Subject: UniStar Nuclear Energy, NRC Docket No. 52-016
Partial Response to Request for Additional Information for the
Calvert Cliffs Nuclear Power Plant, Unit 3,
RAI No. 315, Seismic System Analysis

**Response to NRC Request for Additional Information,
RAI 315, Question 03.07.02-63
Seismic System Analysis,
Calvert Cliffs Nuclear Power Plant, Unit 3**

Question 03.07.02-63

Figure 3.7-82 — {View of Typical Bay Perpendicular to the Turbine Generator (GT Strudl Finite Element Model)}

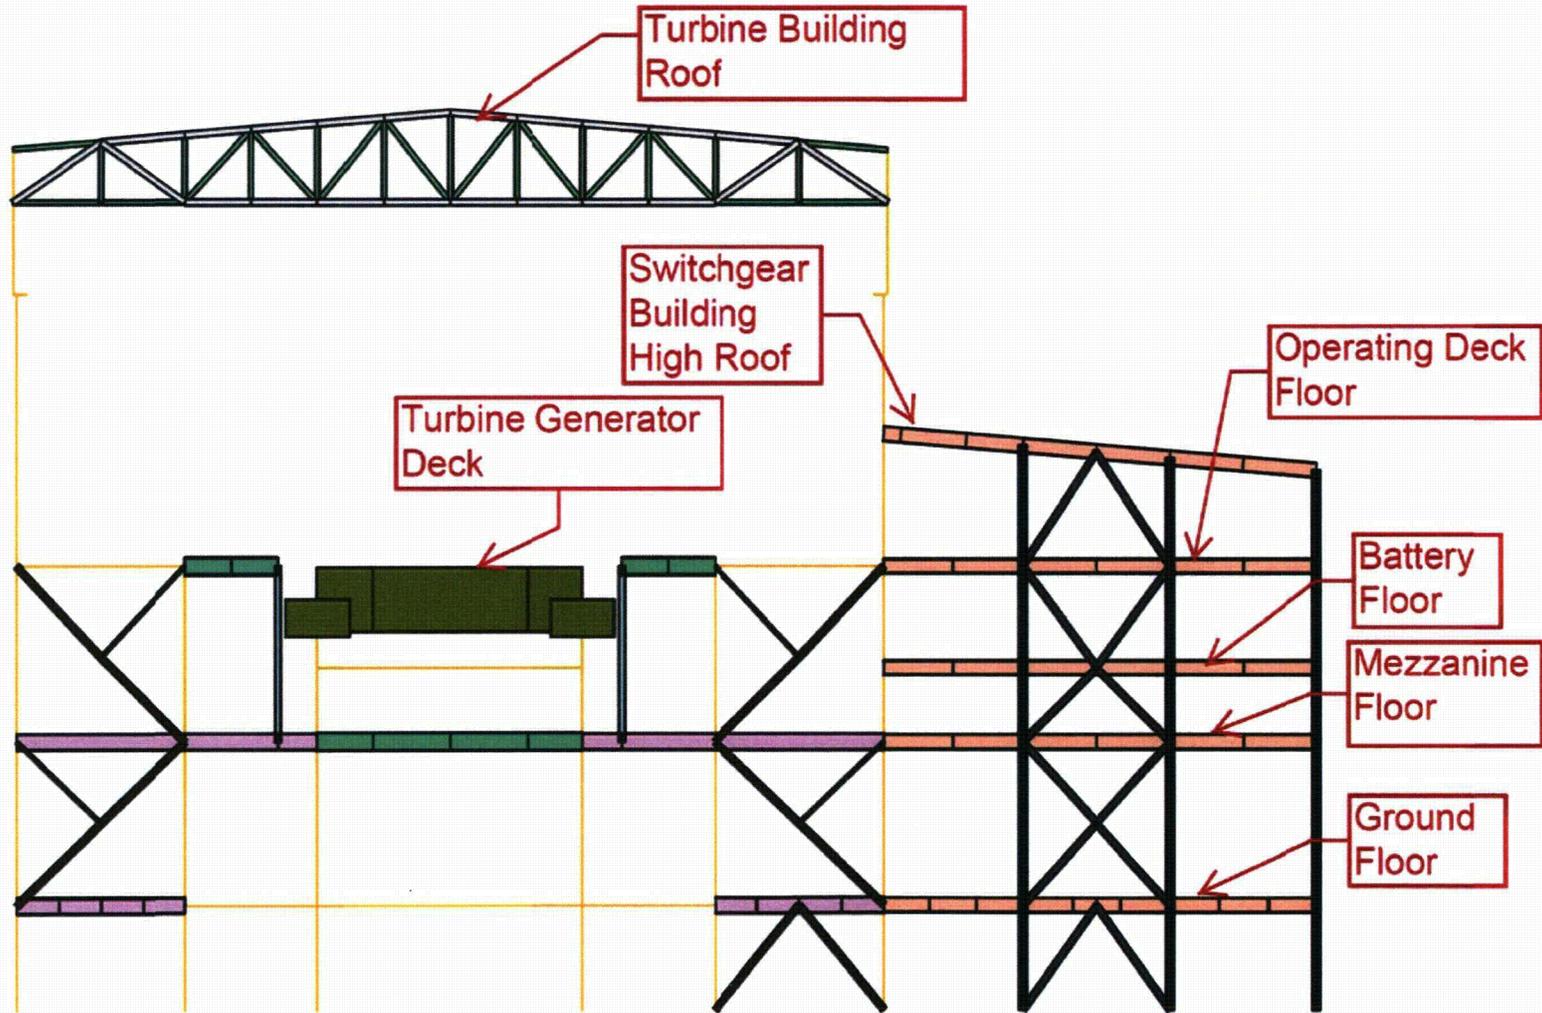
In its partial response to Question 03.07.02-46, the applicant stated that the TB, SB, and AB will be analyzed and designed to prevent their failure under site-specific SSE loading conditions with a margin of safety equivalent to that of Seismic Category I structures. In addition the applicant states that to assure there is no seismic interaction between these Seismic Category II structures and the nearest Seismic Category I structure it will be verified that the separation distances are greater than their combined elastic deformations. However, for the staff to complete its review following the guidance provided in SRP 3.7.2, and be able to conclude that seismic interaction will not occur between the Seismic Category I structures and site-specific Category II structures, the applicant is requested to provide the seismic input, assumptions, modeling techniques, and methods of dynamic analysis that are used to determine the seismic loads required for design of the Seismic Category II structures. In addition, the applicant is requested to describe how these structures are designed to have a margin of safety equivalent to that of category I structures, and how the displacements for these structures are determined so as to verify the separation distances between the Seismic Category I structures and site-specific Category II structures are adequate. The applicant is also requested to provide the methods used to determine the seismic stability of these structures and to provide the results including the factors of safety against sliding and overturning. Also, include site-specific ITAAC for each structure to confirm that the as-built structure is analyzed and designed as described in the FSAR.

As described in Section 3.7.2.3.3, an integrated finite element model is developed for the TI Structure. The complex frequency response analysis method is used for the seismic Soil Structure Interaction (SSI) analysis of the structure, with earthquake motion considered in three orthogonal directions (two horizontal and one vertical), as described in Section 3.7.2.6. The SSI analysis of site specific structures is performed, as described in Section 3.7.2.4, using Bechtel computer code SASSI2010, Version 1.1.

| Change ID # | Subsection | Type of Change | Description of Change |
|--|-------------------------------|--|--|
| CC3-13-0101 | Figures 3.7-82 through 3.7-86 | Incorporate COLA markups associated with the response to RAI 315 Question 03.07.02-63 (this response). | Added Turbine Island structure seismic related Figures 3.7-82 through 3.7-93b. |

Figure 3.7-85 — {Turbine Island Upper Bound Soil Case - Required Coefficient of Friction for Sliding}

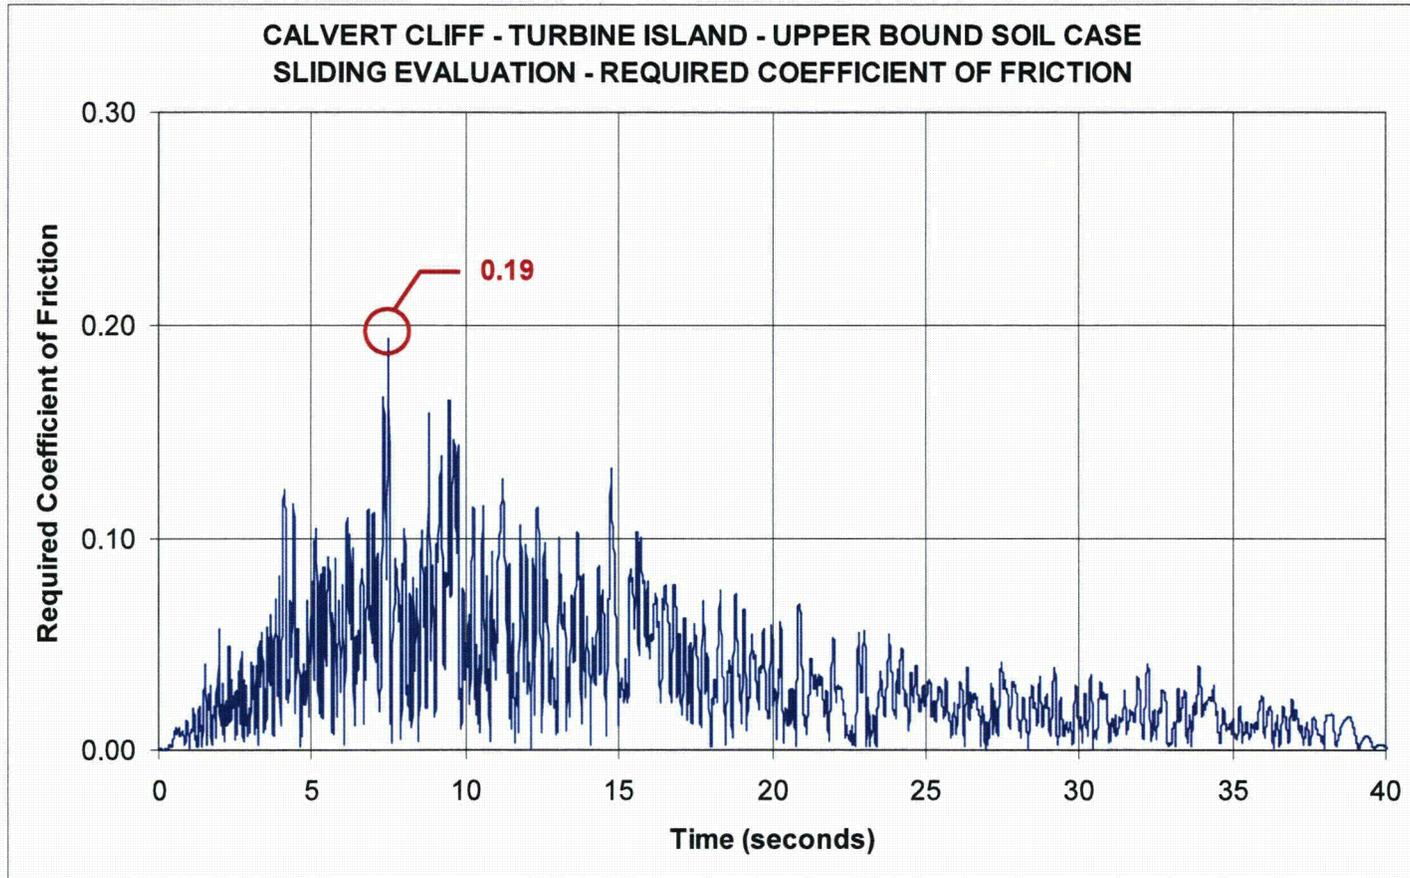
3. Provide the methods used to determine the seismic stability of these structures and to provide the results, including the factors of safety against sliding and overturning.

In the Upper Bound case, following the time step methodology described in Section 3.7.2.4.6.4, the actual sliding effects are calculated at each time step of 0.005 seconds. As a result of this evaluation, the required coefficient of friction for the Upper Bound soil case is 0.19 (see Table 3.7-10a and Figure 3.7-85). The calculated factor of safety (FOS) is therefore 2.68 for the Upper Bound case.

Table 3.7-10a indicates that the maximum required coefficients of friction for the Lower Bound and Best Estimate soil cases are 0.33 and 0.45, respectively. These coefficients of friction are calculated using maximum absolute demand forces as described in Section 3.7.2.4.6.4. The resulting FOS are 1.16 and 1.58 for the Lower Bound and Best Estimate soil cases, respectively. All factors of safety are larger than the required FOS of 1.1 for SSE per NUREG 0800 Standard Review Plan (SRP) 3.8.5. However it is important to note that in the two latter cases, conservatism is included in the analysis, and it is expected that if, similar to the Upper Bound case, time-step methodology were used, the calculated factors of safety would be larger than reported.
